Groundwater Application Review Summary Form

Application # G- 19071

GW Reviewer Stacey Garrison/Travis Brown Date Review Completed: 6/17/2022

TO: Water Rights Section Date 6/17/2022
 FROM: Groundwater Section Stacey Garrison/Travis Brown
 Reviewer's Name
 SUBJECT: Application G- 19071 Supersedes review of _____
 Date of Review(s) _____

Water-Level Measurements in Nearby Wells

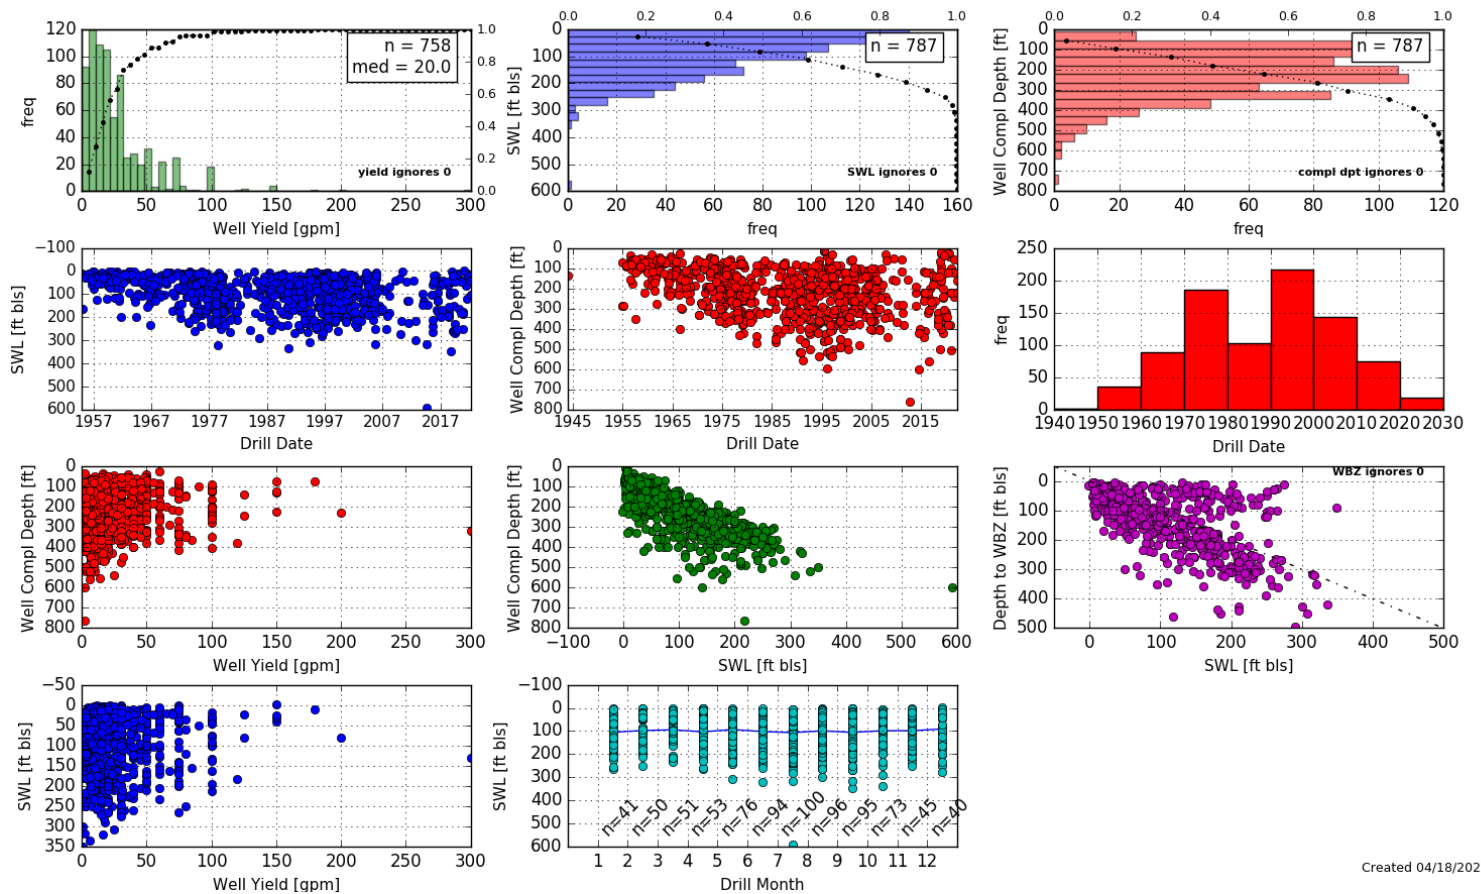
Nearby water level monitoring within the CRBG aquifer(s) does not indicate progressive or widespread declines (see **Water Level Measurements in Nearby Wells**). Groundwater supplies would therefore appear to be adequate for existing users. However, additional pumping may lead to rapid declines within the aquifer. Furthermore, the available observation wells are more than 0.5 miles away from the proposed POA. In the faulted and eroded terrain of the South Salem Hills, aquifer conditions may be expected to change substantially over short distances. The South Salem Hills Groundwater Limited Area has been designated to address the sensitivity of these aquifers to pumping.

Theis Drawdown Analysis

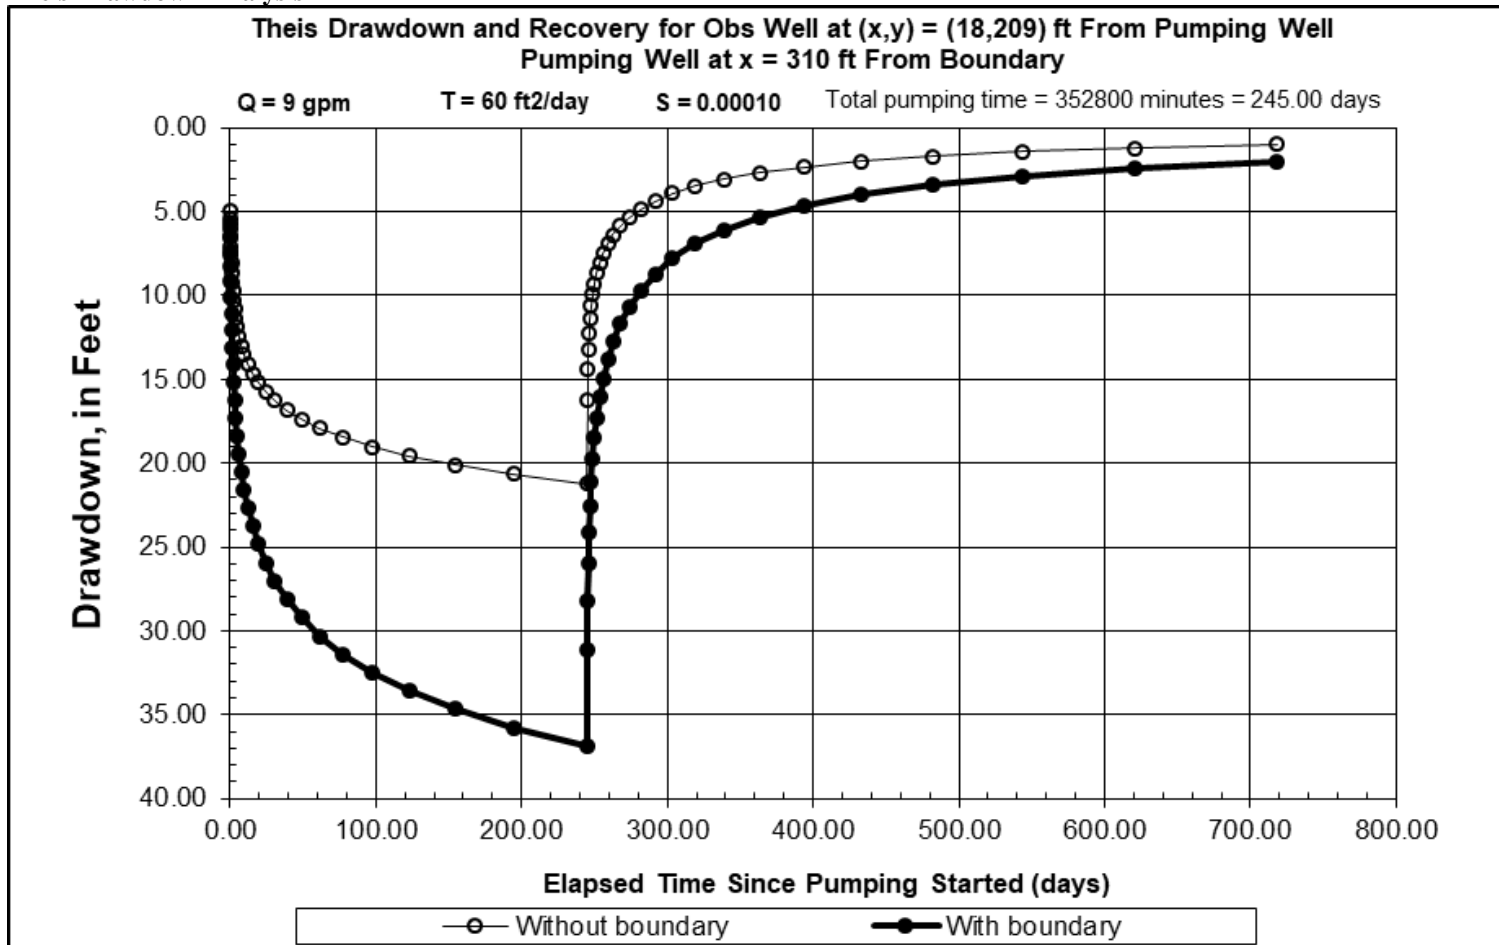
some degree of well-to-well interference with the domestic well at 3371 Vitae Springs. To assess the degree of drawdown, analysis was conducted for the proposed use using the Theis equation for drawdown in a confined aquifer (see **Theis Drawdown Analysis**). Results indicate that well-to-well interference with the neighboring well would exceed 15 ft of drawdown within less than 1 week of continuous operation at the average rate of 0.02 cfs (9.2 gpm)*, which would require curtailment of the proposed use per Condition 7i, above. The proposed use is not likely within the capacity of the resource.

*The full pumping rate could not be utilized continuously for the entire 245-day period of use without exceeding the 10 ac-ft maximum allowed duty. For the maximum allowed duty of 10 ac-ft, continuous pumping would occur for 245 days at a rate of 0.02 cfs (9.2 gpm). Use at the maximum proposed rate of 0.125 cfs (56 gpm) would result in drawdown that exceeds 15 ft even sooner than with the average rate.

Based on this analysis of the available data and under the assumptions previously identified, groundwater for the proposed use is not likely available in the amounts requested within the capacity of the resource. If a water right is permitted for this application, the conditions specified in B1.d., B2.c, and B3 are strongly recommended to protect senior users and the groundwater resource.
